CCR Number: 0002

**NEW MILLENNIUM PROJECT CONFIGURATION CHANGE REQUEST**

| PROGRAM <u>EQ-1</u><br>CCR NO. <u>0002</u><br>DATE INITIATED <u>12/03/97</u>                         | TITLE <u>Rev A TO EO-1 SPACECRAFT ALI ICD-18</u><br>ORIGINATOR <u>Swales Aerospace</u><br>ORIGINATOR'S CHG. NO. <u>SAI-018</u><br>SPONSOR/CODE <u>M. Jurotich/EO-1 Payload Mgr</u> PHONE <u>x5919</u>  |   |                                   |  |  |         |                                    |   |                                   |   |  |                                |                                |  |                                     |                                 |                                |
|--|--|---|-----------------------------------|--|--|---------|------------------------------------|---|-----------------------------------|---|--|--------------------------------|--------------------------------|--|-------------------------------------|---------------------------------|--------------------------------|
| EFFECTIVITY<br>ITEM: <u>ALL</u><br>S/N _____<br>ITEM: _____<br>S/N _____<br>ITEM: _____<br>S/N _____ |

EO-1 ICD-18  
Rev A Draft  
October 20, 1997

**Figure 3.1 EO-1 Configuration** (outer panels not shown)

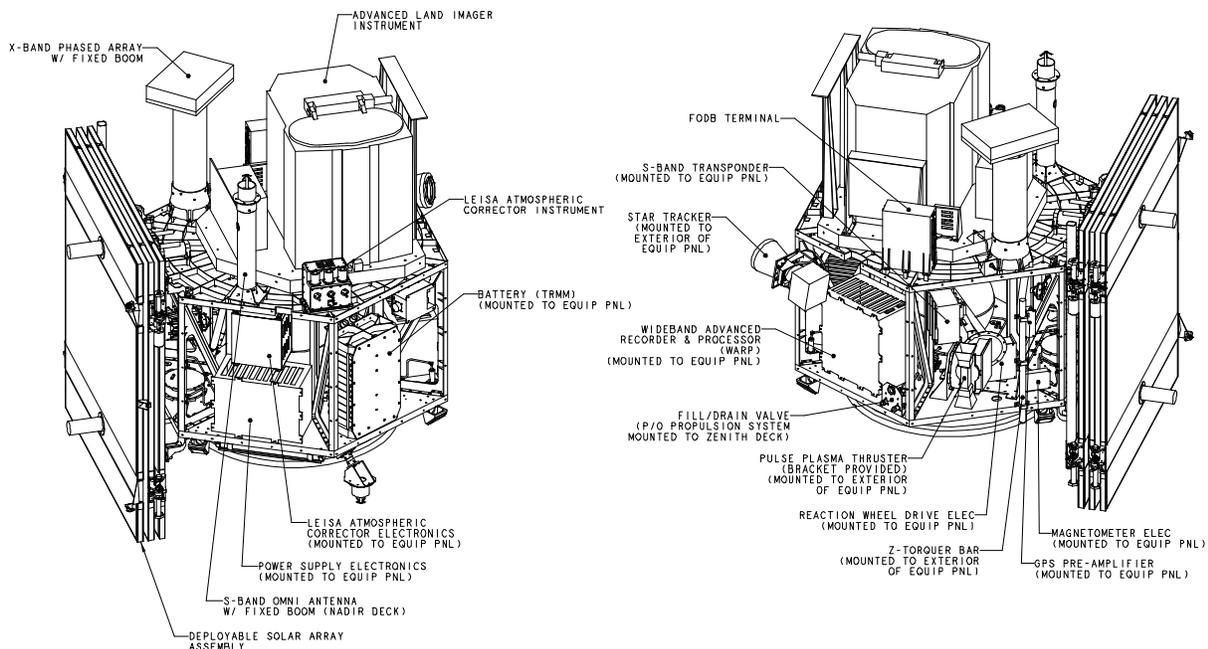
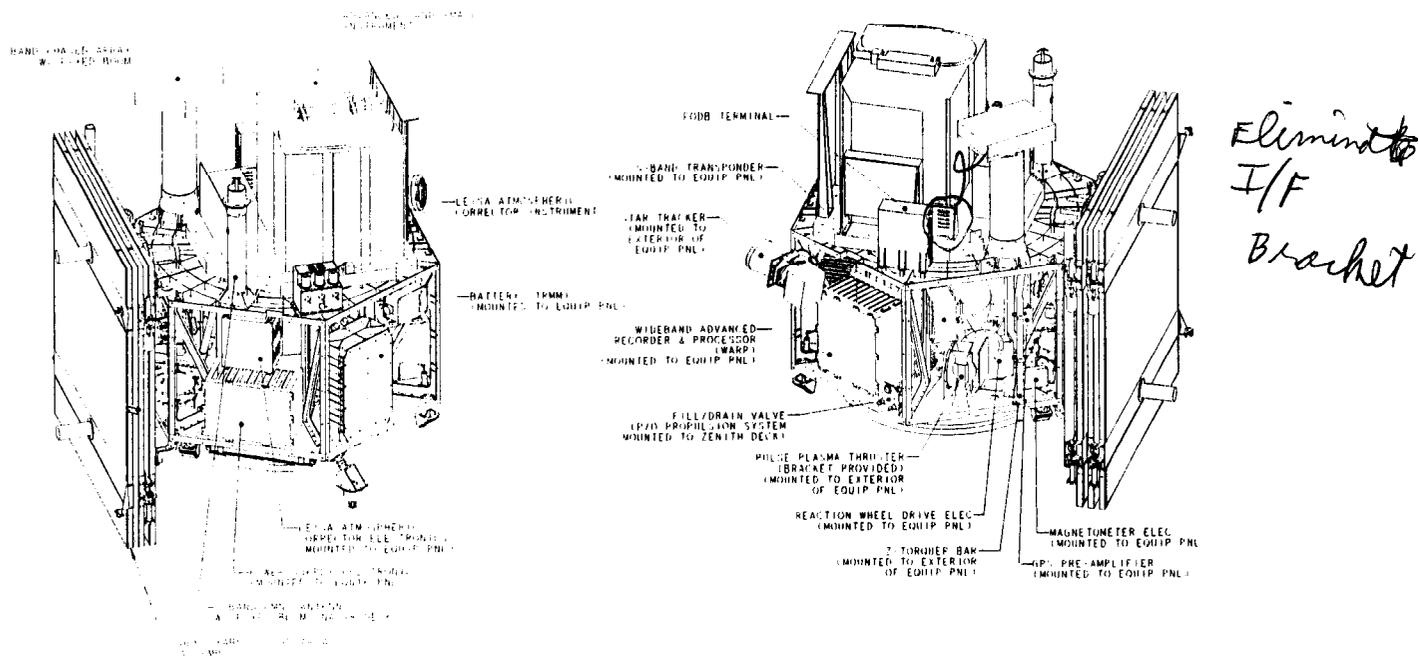
Figure 3.1 EO-1 Configuration: Eliminate I/F Bracket.

Sponsor Comment: **Agree**, however, will accomplish on a next CCR to be written, NOT in this B/L version.

**Figure 3.2 ALI Coordinate System**

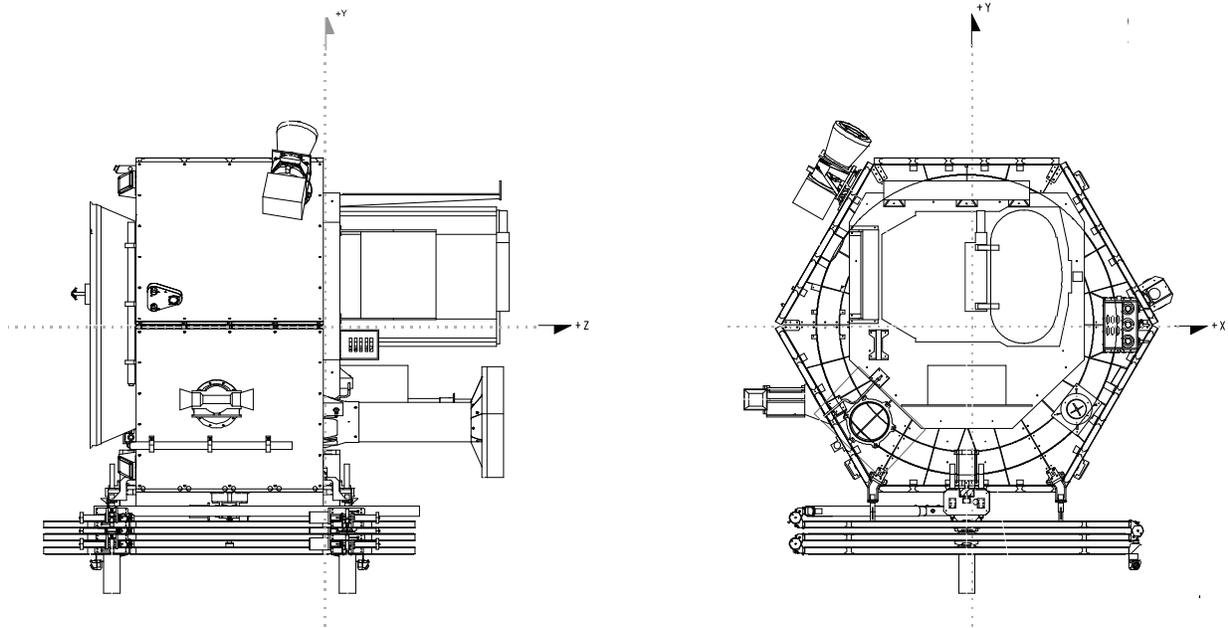
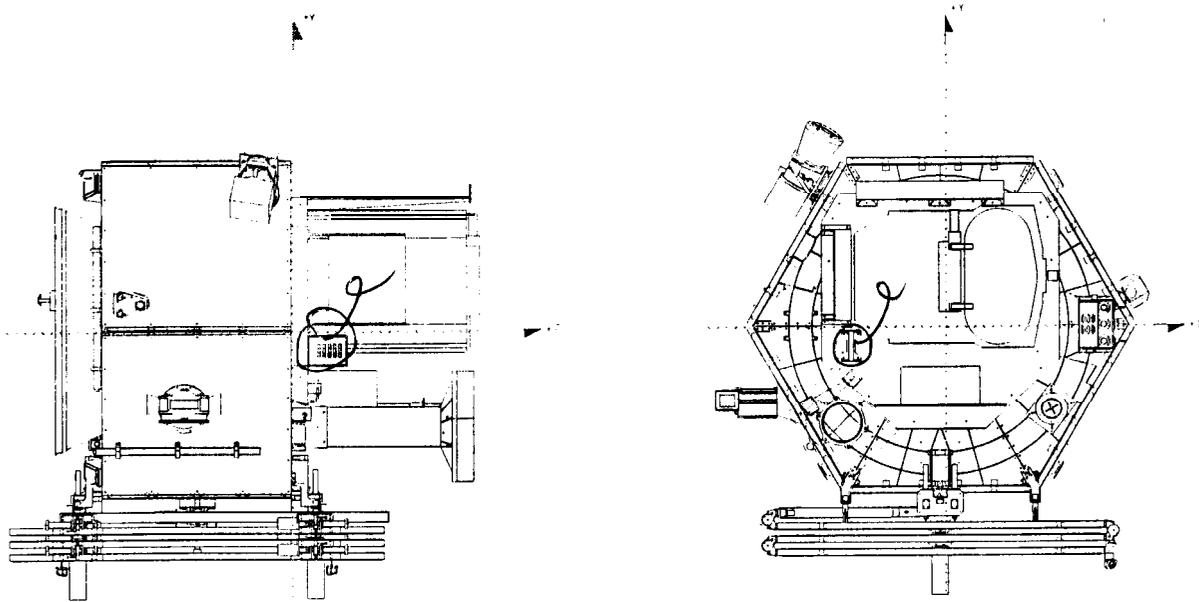
Figure 3.2 is does not adequately show detail connector location and orientation.

Sponsor Comment: **Agree.** Incorporate “TBR”.

### **Figure 3.4 Survival Heater Redundancy Concept**

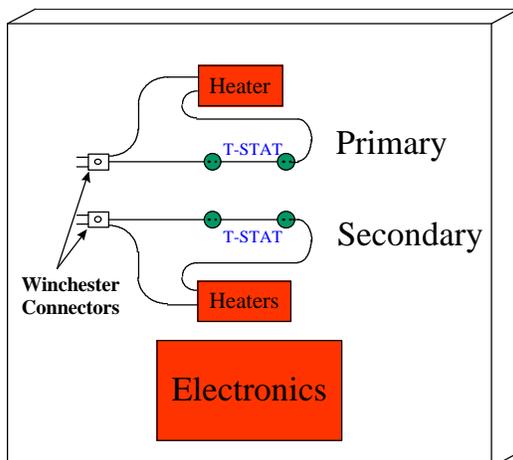
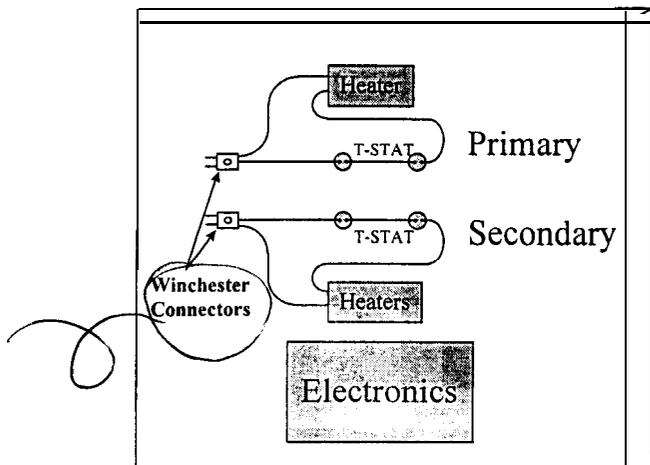
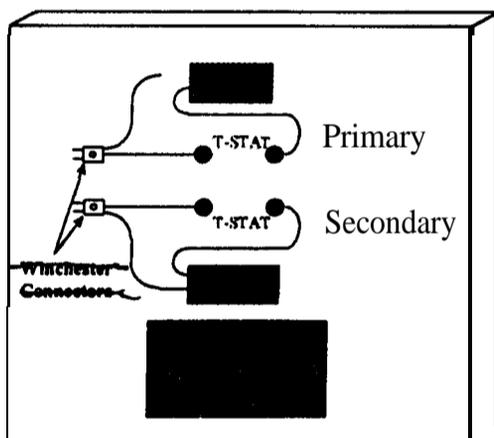
Figure 3-4: **Delete** “Winchester Connectors referenced in figure 3-4.

Sponsor Comment: **Agree.** Incorporate change as stated.

Figure 3.5 Instrument Electrical Block Diagram

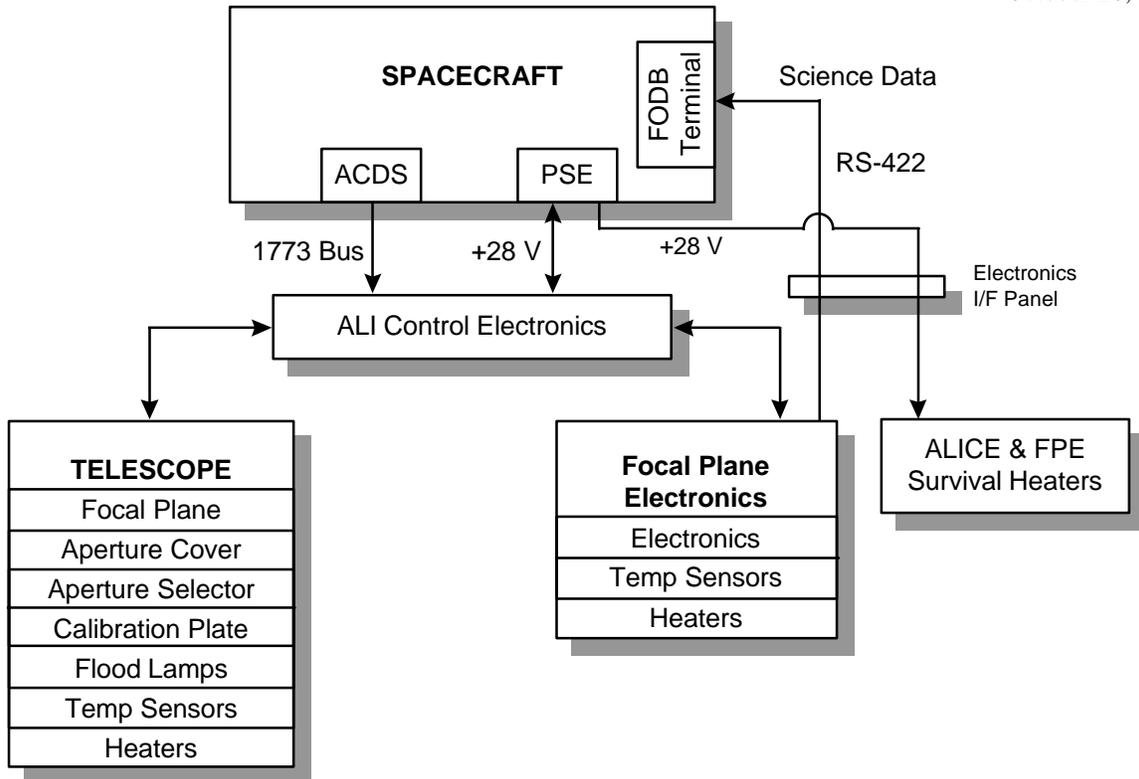
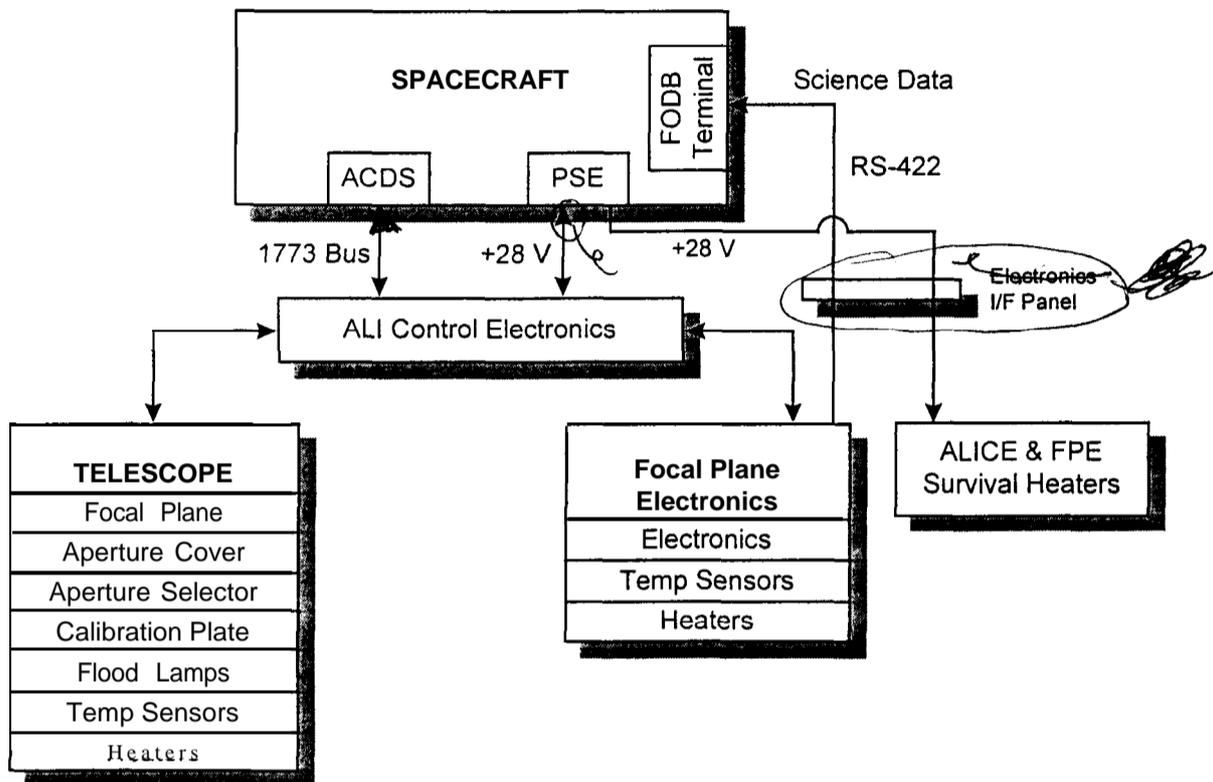
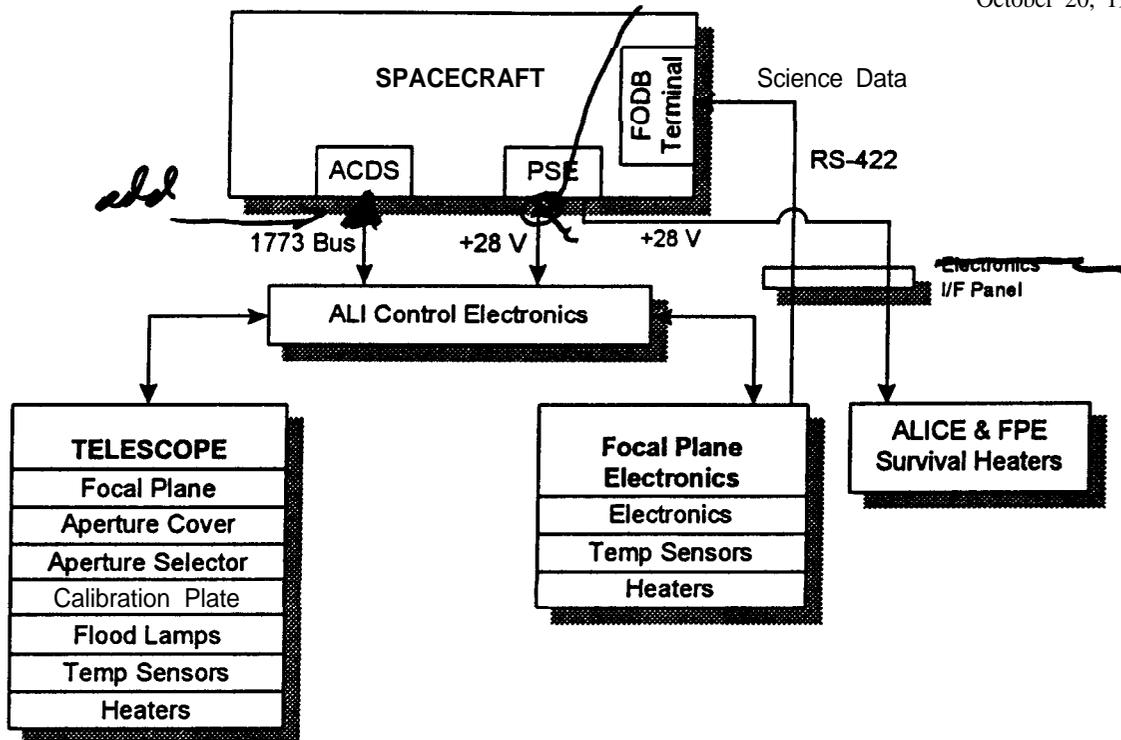
Figure 35 Instrument Electrical Block Diagram

**Delete: Electronics** from “Electronics I/F Panel reference.

**Add:** Arrow head on 1773 Bus from ALI Control Electronics to ACDS on Spacecraft.

**Delete:** Arrow head on +28 V from ALI Control Electronics to PSE

Sponsor Comment: **Agree.** Incorporate change as noted.
